# STAFF RECOMMENDATION

NCPC File No. 6321

**NATIONAL LAW ENFORCEMENT MUSEUM  
ENTRANCE PAVILIONS AND PLAZA  
JUDICIARY SQUARE, NW  
Washington, D.C.**

March 29, 2007

**Plaza Scheme from February 2007 Submission with 36 foot wide opening** →

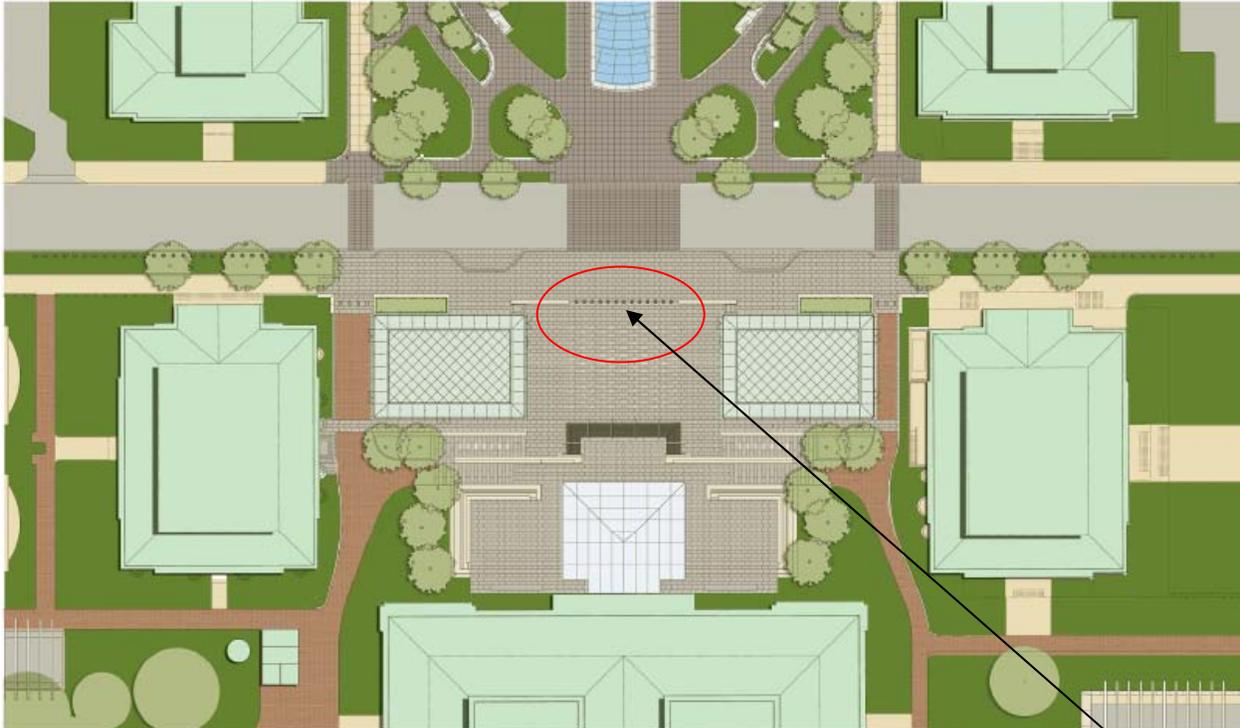
1. Some elements of the design, namely the two proposed plaza retaining walls and the pavilion revolving doors, may not be permissible under the project's authorizing legislation, which requires that no above ground elements of the Museum be placed in the 100-foot-wide area centered on the Old D.C. Courthouse.

2. The retaining walls impeded access to the District of Columbia Courts and within the Judiciary Square precinct.
3. The submission must include a perimeter security line for the District of Columbia Courts in accordance with the approved Judiciary Square Master Plan.

1. The pedestrian passage between the proposed retaining walls has been increased from 36 feet to 55 feet, 7 inches; and the plaza grading modified accordingly.

**Proposed Revised Plaza Scheme with 55 foot, 7 inch wide opening and Perimeter Security** →

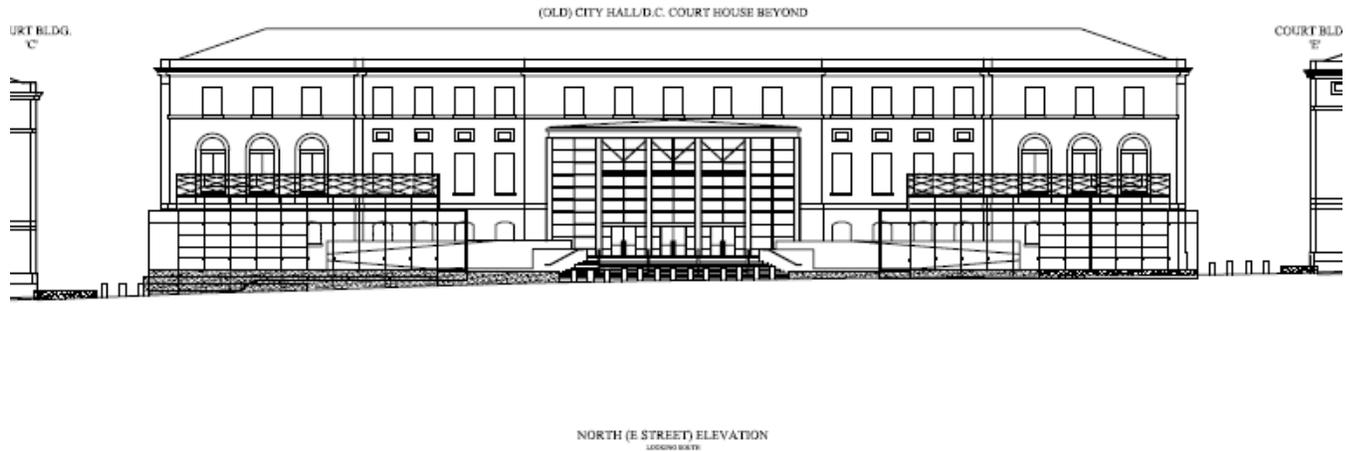
2. Perimeter security has been added to accommodate the requirements of the District of Columbia Courts, and the retaining walls have been incorporated into the perimeter security line.

**Directs the applicant to** increase the height of the proposed perimeter security/retaining walls to 30 inches to meet the District of Columbia Courts' security requirements.

**Section through Skylight Element in Plaza**

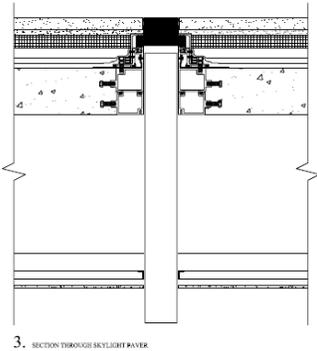
4. Additional information was needed to evaluate the proposed skylight elements in the ramps leading to the Old D.C. Courthouse.
5. The proposal included elevating E Street and that this proposal had not been coordinated with NCPC staff or with other parties to ongoing consultation on the project.

3. Additional information has been provided about the design of proposed skylight elements in the ramps leading to the Old D.C. Courthouse.
4. Additional information has been provided regarding the need to elevate E Street, NW.

**Comparison of Plaza Grading with and without Retaining Walls**

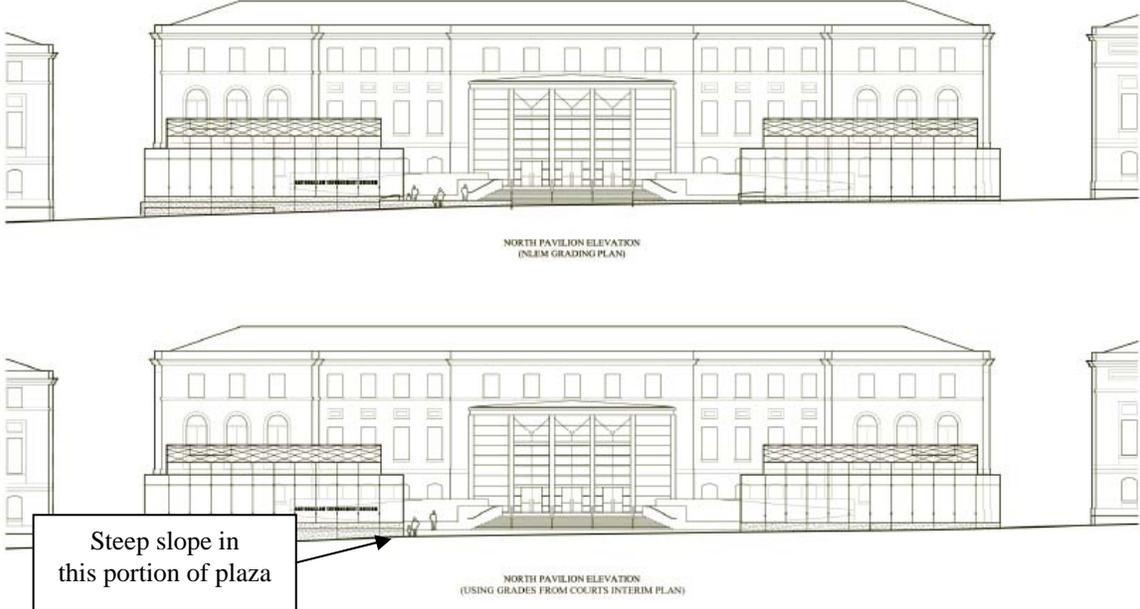
The current submission for the Museum requires retaining walls on either side of the plaza centerline in order to flatten the plaza grade to improve its appearance and function. Without the walls, the plaza would appear slanted downward from west to east, and the area of the plaza along the west façade of the east Museum entrance pavilion would be extremely steep. Although the plaza could be graded without the walls and still meet requirements of the Americans with Disabilities Act (ADA), the resulting grade would not be ideal from an urban design standpoint.

The Fund's proposed retaining walls accomplish the same result as that of the Courts' approved interim plaza design, which also employed retaining walls to achieve this correction in grade. In fact, the Museum proposal is markedly similar to that of the Courts. Both use a combination of walls and bollards across the front of the plaza, and both achieve an opening through the center of the plaza of approximately the width of the Old D.C. Courthouse steps. In the case of the Courts, the opening is approved at approximately 60 feet, while the Museum proposes 55 feet, 7 inches. Both proposals place above-ground elements in the 100 foot-wide-area centered on the Old D.C. Courthouse.

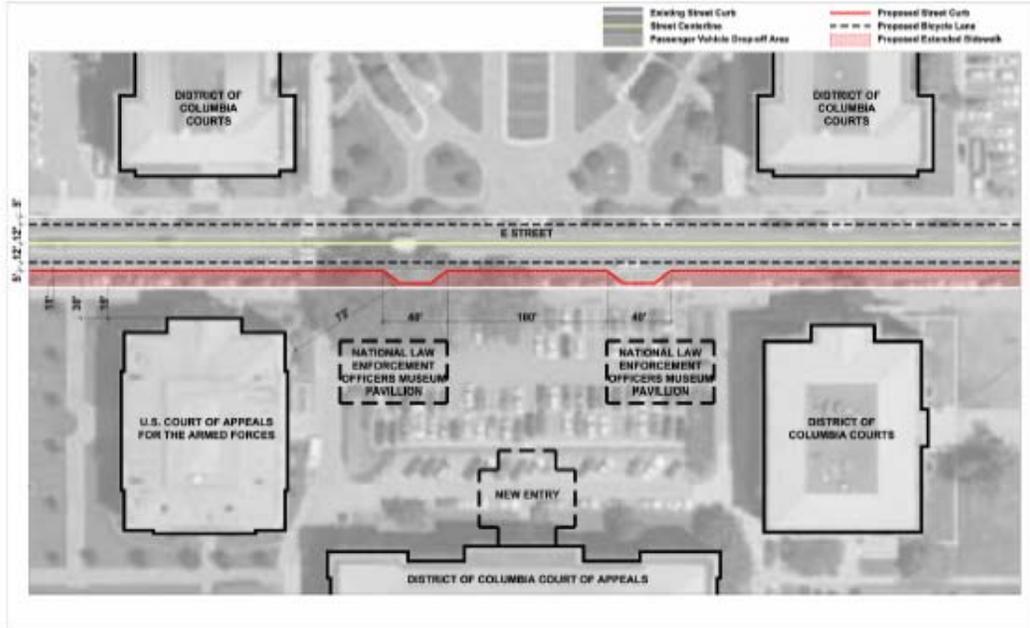
Public Law 106-142, authorizing the Museum, requires that "no portion of the aboveground portion of the Museum is located within the 100-foot-wide area centered on the north-south axis of the Old City Hall [Old D.C. Courthouse]." Staff notes that some elements of the design, while they may represent the best architecture and urban design solutions, may not comply with the project's authorizing legislation. These elements are the proposed retaining walls and portions of the revolving doors used for entering each Museum pavilion. Additionally, the landscaped areas at the south side of each pavilion are proposed for an area where no above ground construction is permitted by the legislation. The Fund will need to obtain clarification on intent of the legislation or build consensus with the District of Columbia Courts on the intent as the project moves forward.
